PUBLIC INTEREST REVIEW FOR GROUND WATER APPLICATIONS

SUBJECT: Application G- 17540 Supersedes review of _____
Date of Review(s)

A. GENERAL INFORMATION: Applicant's Name: Toby Stadel County: Marion

A1. Applicant(s) seek(s) 1.0 cfs from 3 well(s) in the Willamette Basin,
 _____ subbasin Quad Map: Stayton NE

Figure 1. Location of selected CRBG wells near the towns of Mt. Angel and Silverton.

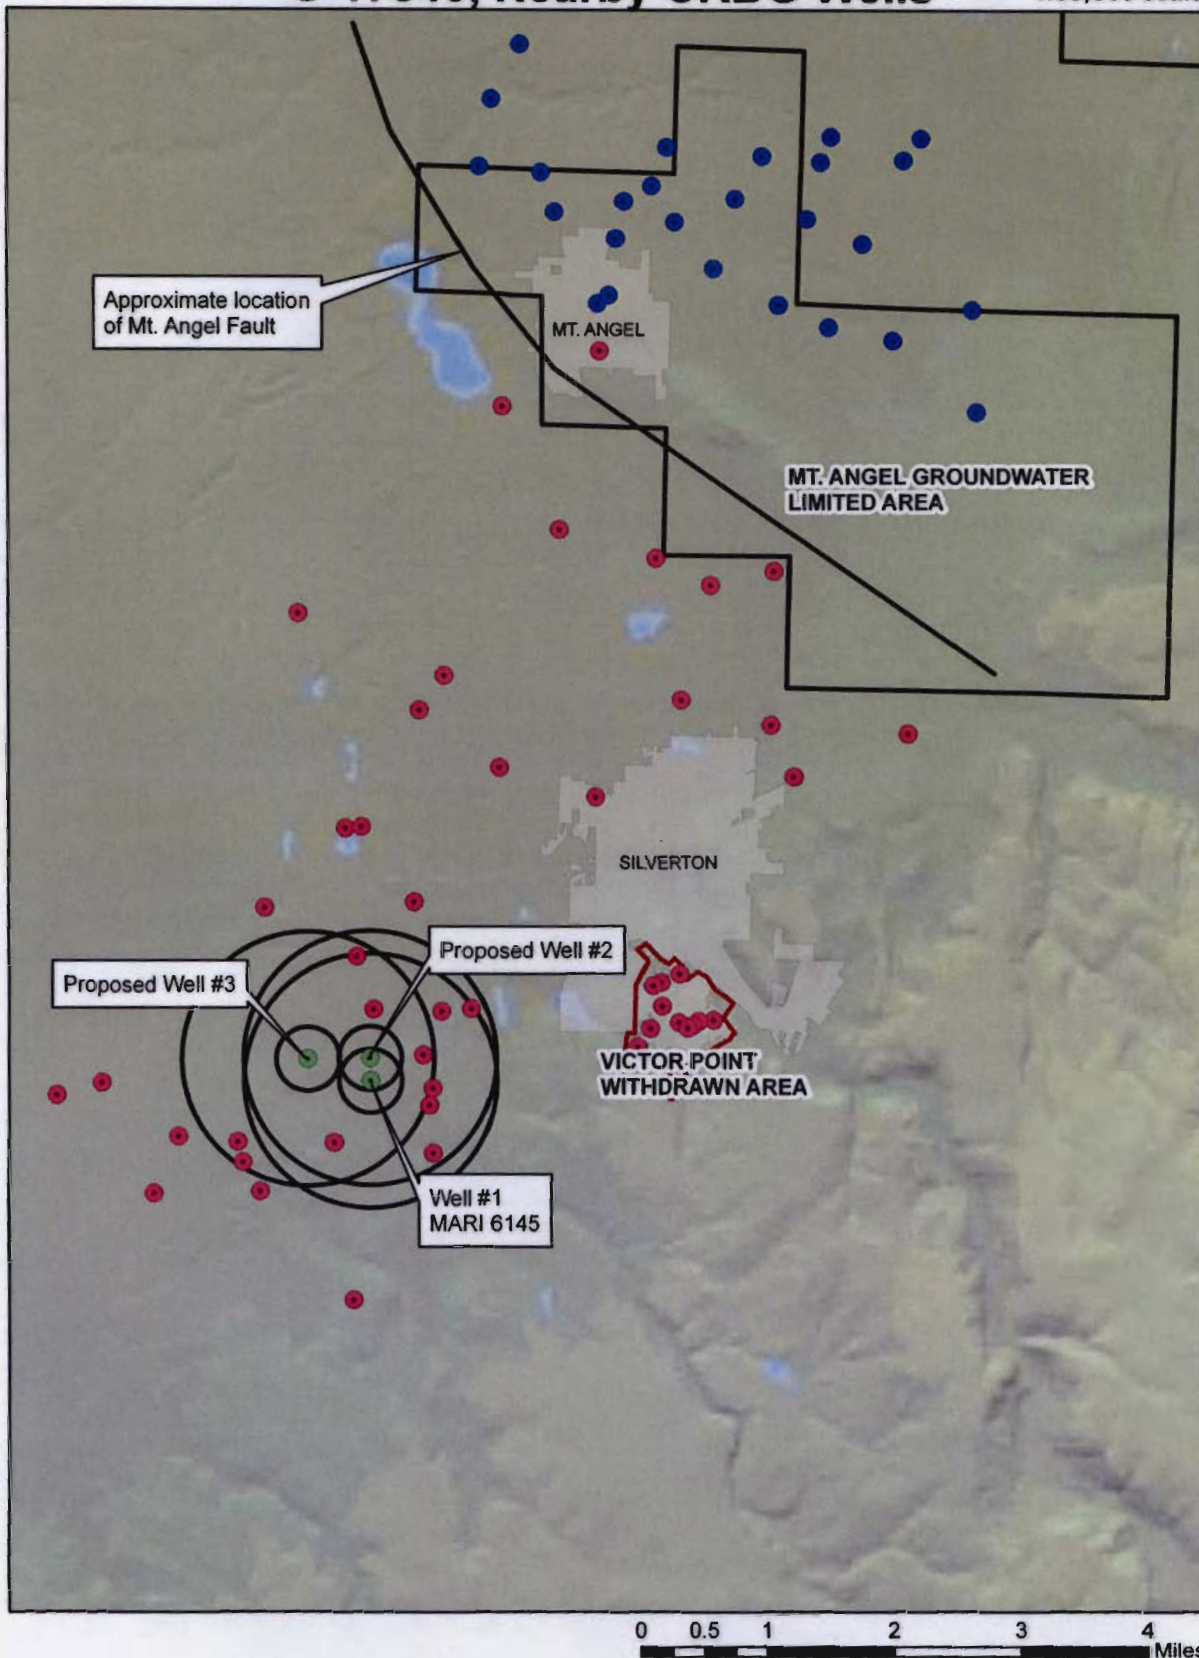
Groundwater declines have been documented in Columbia River Basalt aquifers in many areas on the east side of the Willamette Basin. In fact, several groundwater restricted areas have been created to address the decline problems. The applicant’s wells are located southwest of the Mt. Angel Groundwater Limited Area and the Victor Point Groundwater Withdrawn Area, and northwest of The South Salem Hills Groundwater Limited Area. Water-level declines, however, are not limited to these classified areas and occur over a broad area near the towns of Silverton and Mt. Angel (see Figure 1 for well

Figure 4. Water level elevation trends in nearby wells. Green trends are CRBG wells west of mapped fault, black trends are CRBG wells east of fault, and yellow and black trend is a nearby alluvial well with long-term water levels.

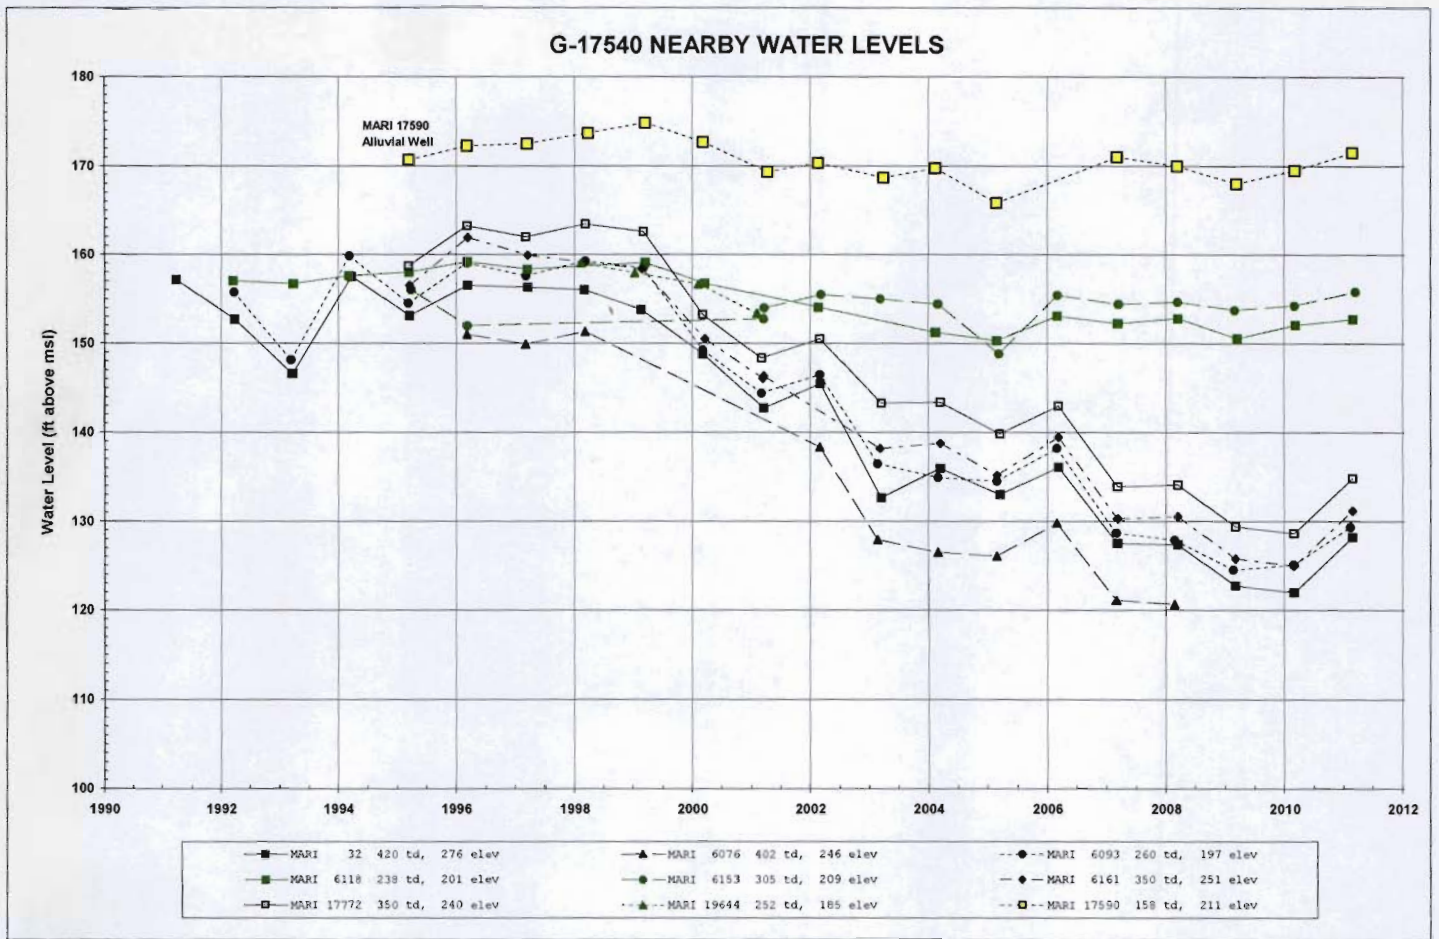
Geologic maps (Tolan and Beeson, 1999) show that southeast of the applicant’s wells, the basalts are broken into many fault-bounded blocks. In the area surrounding the applicant’s wells, the basalts are overlain by approximately 100 feet of alluvial sediments. A northwest-trending normal fault is mapped to the east of the applicant’s wells, but is concealed by sediments, so its exact location is uncertain. The degree to which this fault impedes horizontal flow or enhances vertical flow of groundwater is also uncertain.
